SITE PLAN

REVISIONS FROM ORIGINAL SITE PLAN:

NORTHWOODS PARK RESTROOM REPLACEMENT

DEMOLITION & REPLACEMENT OF EXISTING RESTROOM

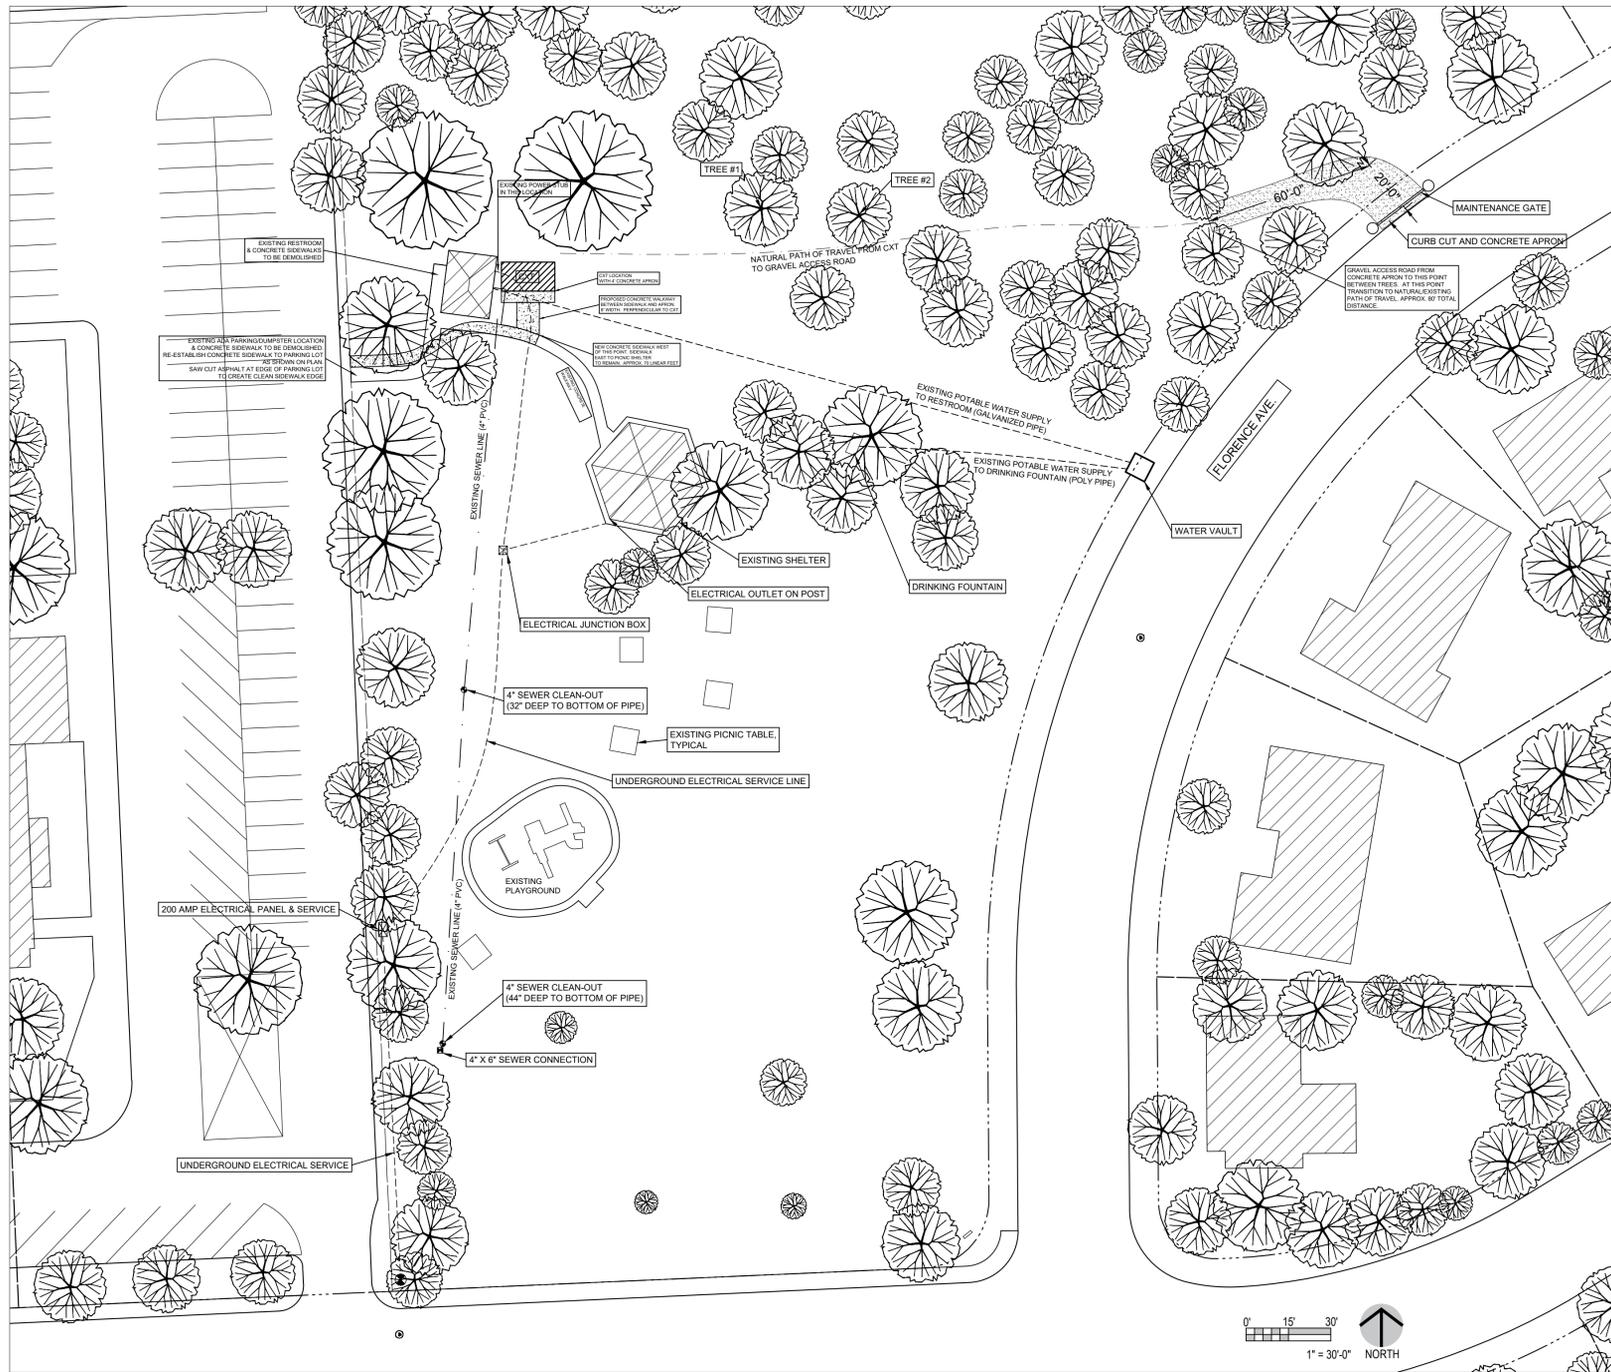
- Re-locate new CXT unit closer to original restroom location as shown on plan.
- Revise irrigation layout in area of new CXT. Ensure head-to-head coverage for all turf areas.

- Connect to existing sewer line at approx. location shown on plan. Sewer depths at clean-outs have been verified and labeled on plan.
- Provide electrical junction box at current location and extend to new location. In the event that existing electrical wiring is undersized, replace with wiring of sufficient size to meet the electrical specifications of the CXT unit. (See CXT engineered drawings)

- Intercept potable water line and re-route to new CXT location.
- Extend gravel maintenance road from concrete apron to a point about 80' from entrance and transition to native soil. Build up maintenance road with basalt ballast rock and infill with 1.5" crushed gravel to provide a solid surface. Remove dead tree branches as needed to provide vertical clearance for CXT crane operations.
